# SAN FRANCISCO PLANNING DEPARTMENT

## Discretionary Review Abbreviated Analysis

*Date:* April 26, 2019  
*Case No.:* **2017-013328DRP-04**  
*Project Addresses:* **2758 Filbert Street**  
*Permit Applications:* 2017.1013.1247  
*Zoning:* RH-2[Residential House, Two-Family]  
40-X Height and Bulk District  
*Area Plan:* N/A  
*Block/Lot:* 0952/013,  
*Project Sponsor:* Kaileen Yen  
Winder Gibson Architects  
1898 Mission,  
San Francisco, CA 94103  
*Staff Contact:* David Winslow – (415) 575-9159  
[David.Winslow@sfgov.org](mailto:David.Winslow@sfgov.org)  
*Recommendation:* **Take DR and approve with proposed modifications**

photo of facade taken from across the street on 1/19/19.  
taken by Irene Holmes

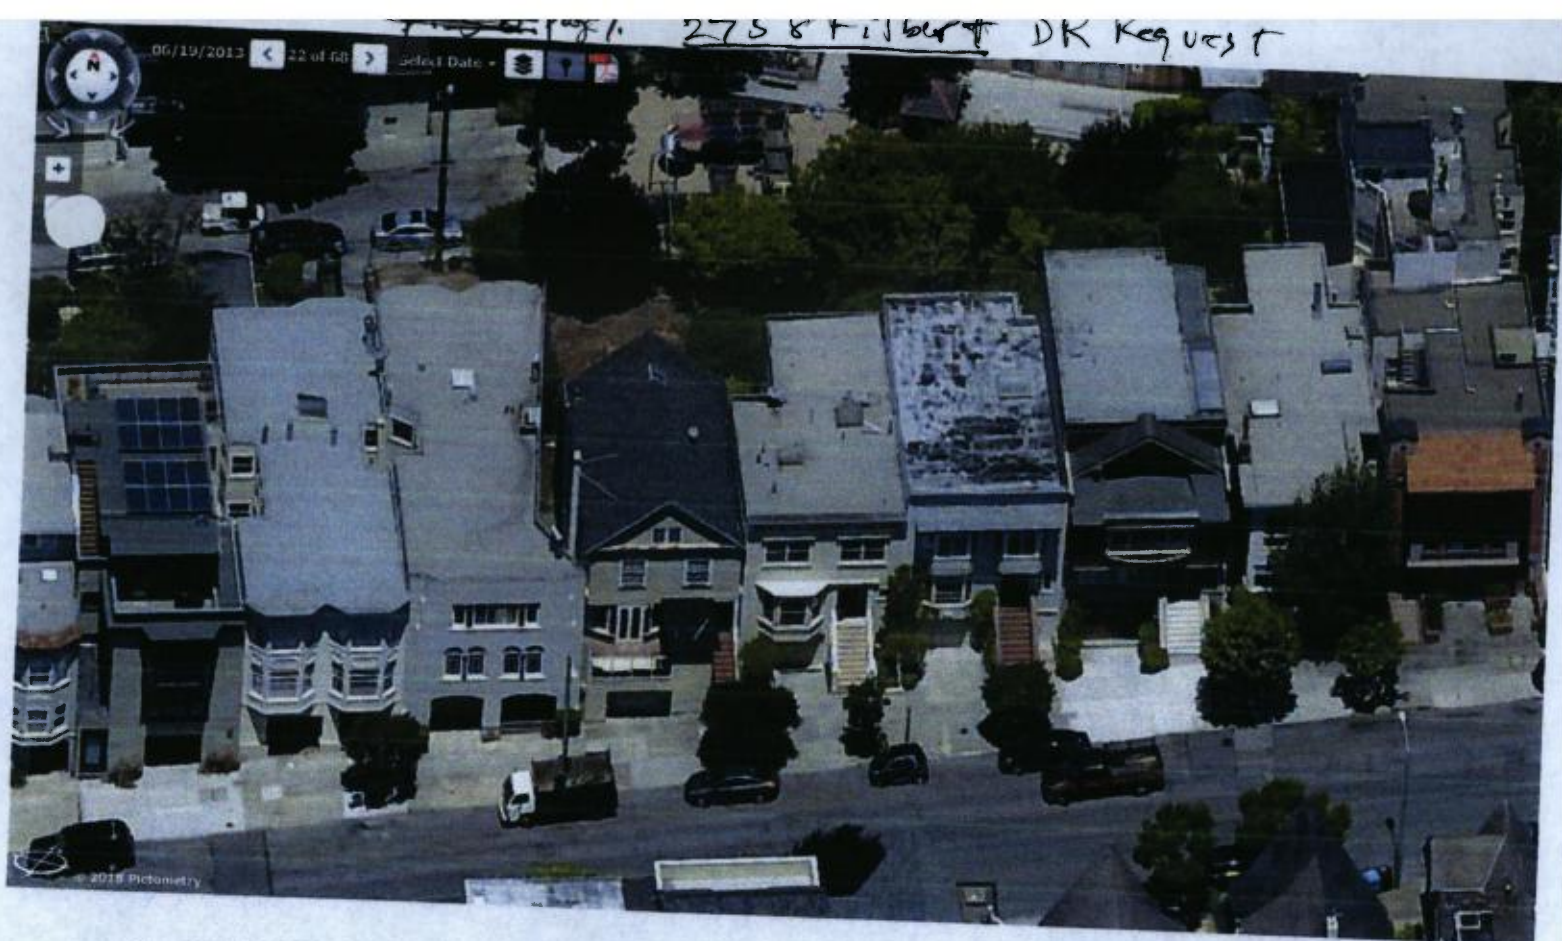
The attached aerial photo of this block, from the Planning Department website data, shows the existing pattern. The photo is dated 2013, but the entry pattern has not changed.

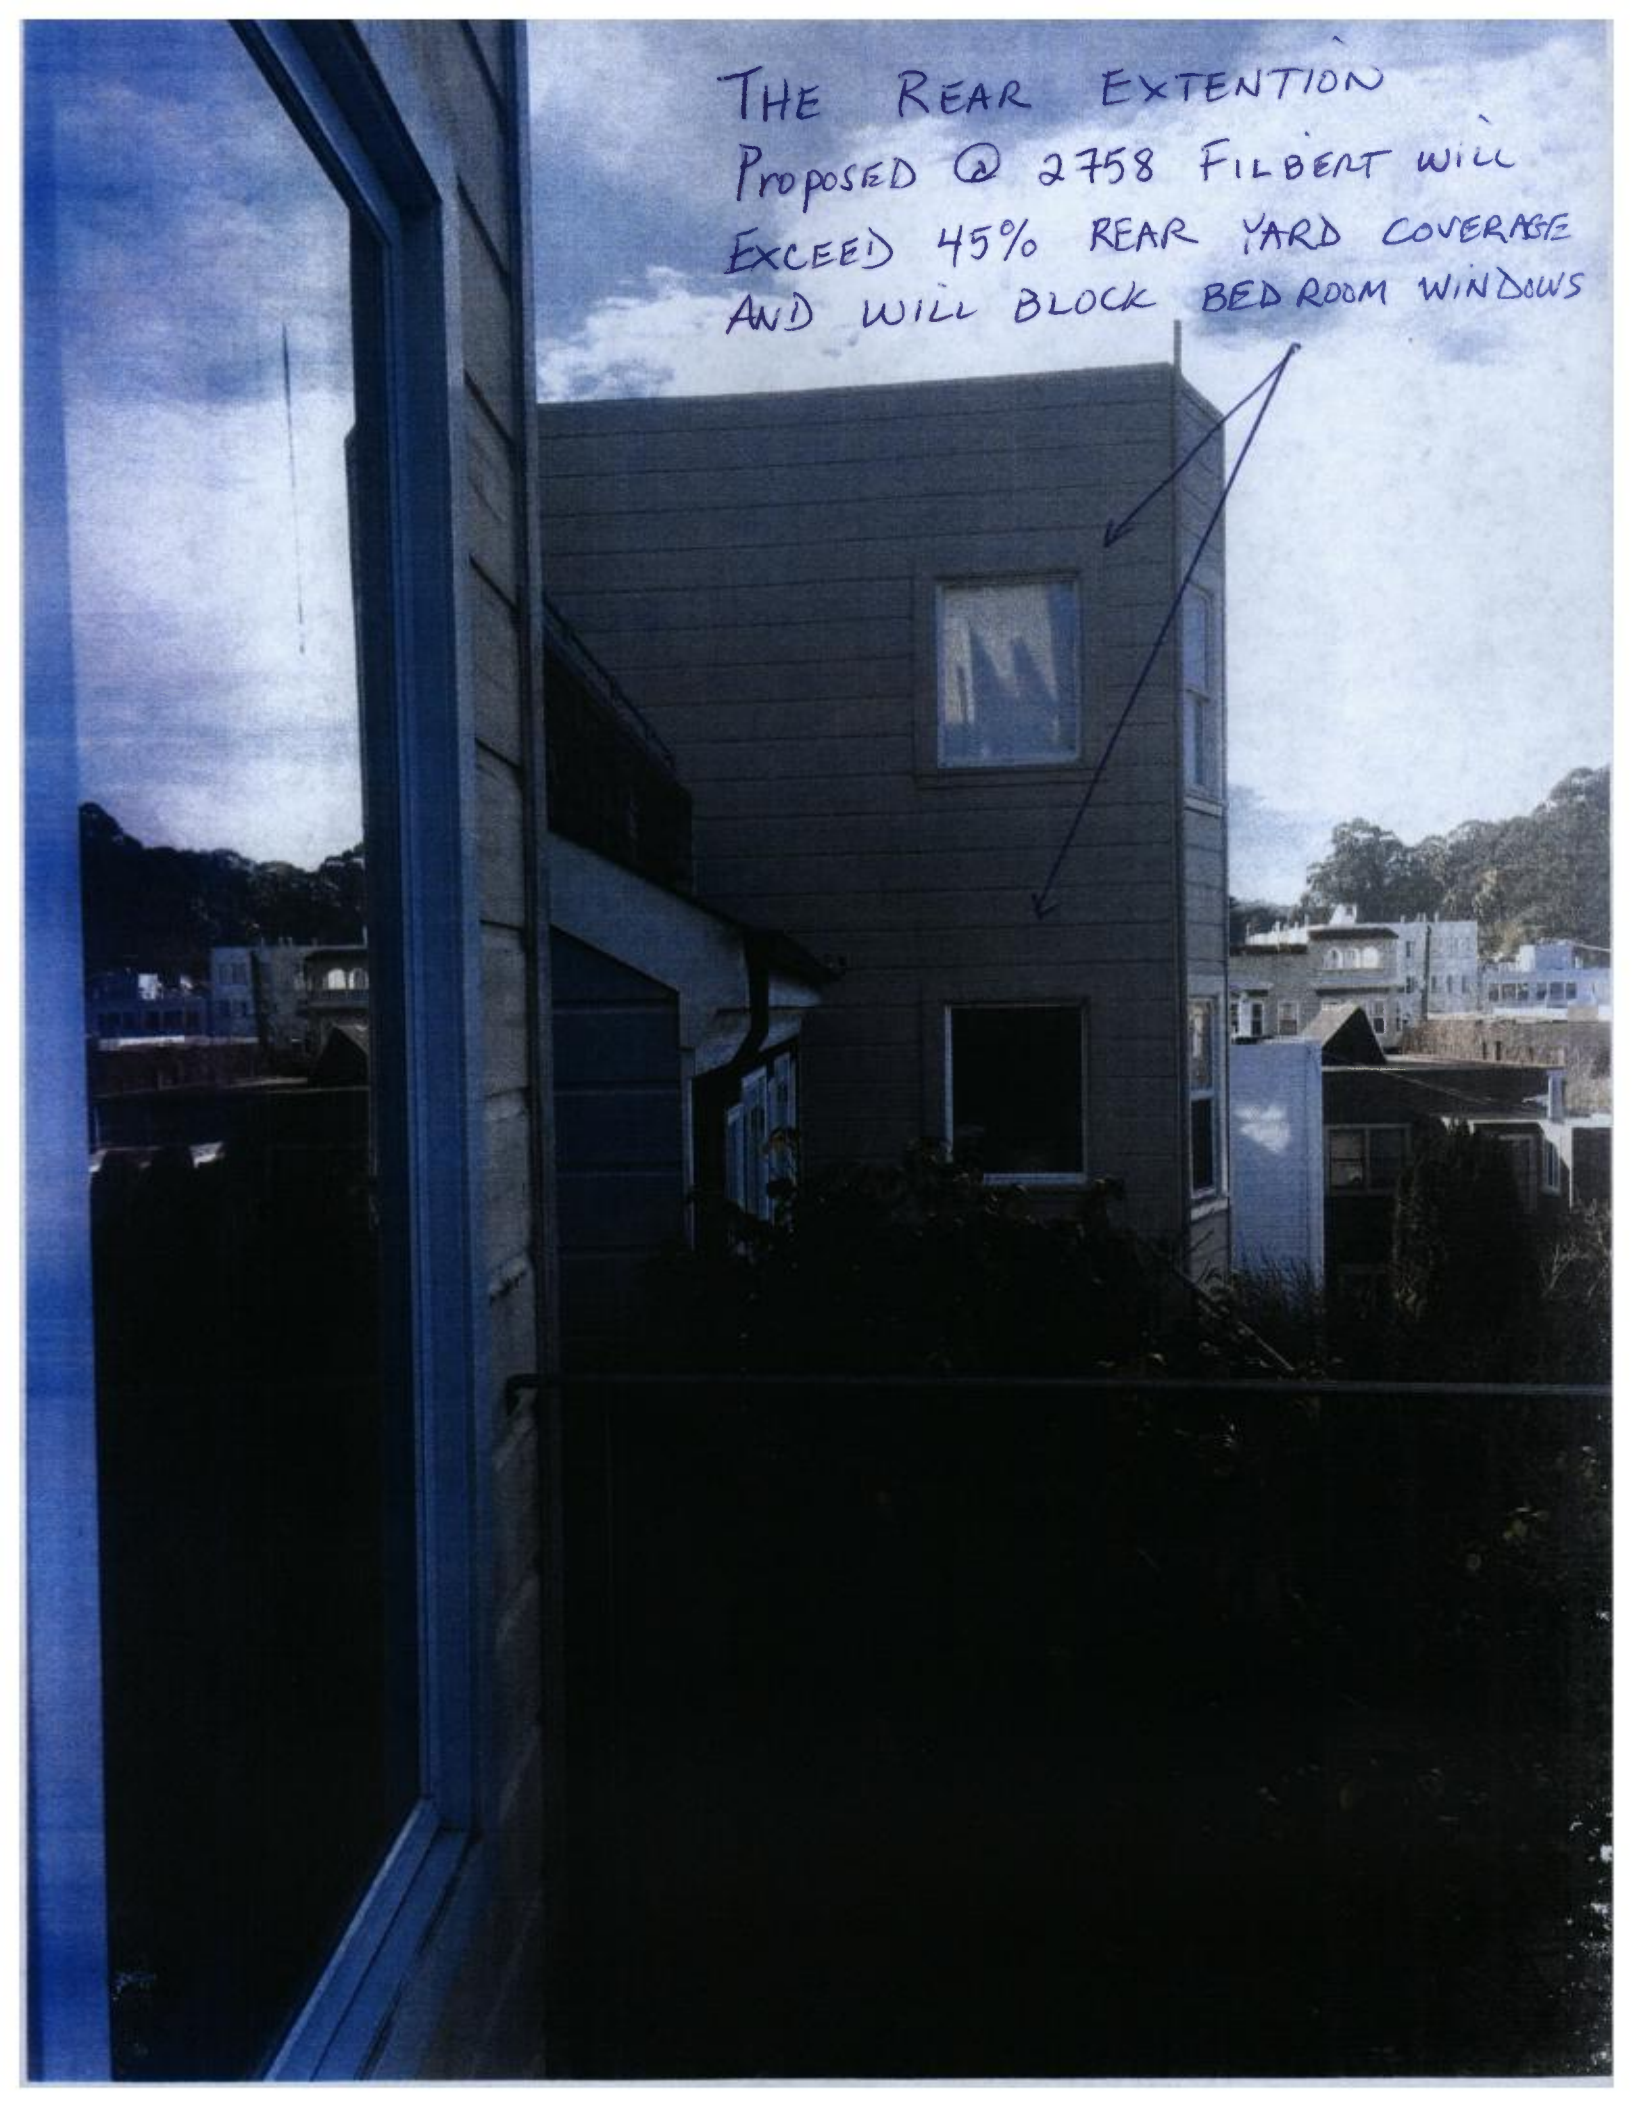
THE REAR EXTENTION  
PROPOSED @ 2758 FILBERT WILL  
EXCEED 45% REAR YARD COVERAGE  
AND WILL BLOCK BED ROOM WINDOWS
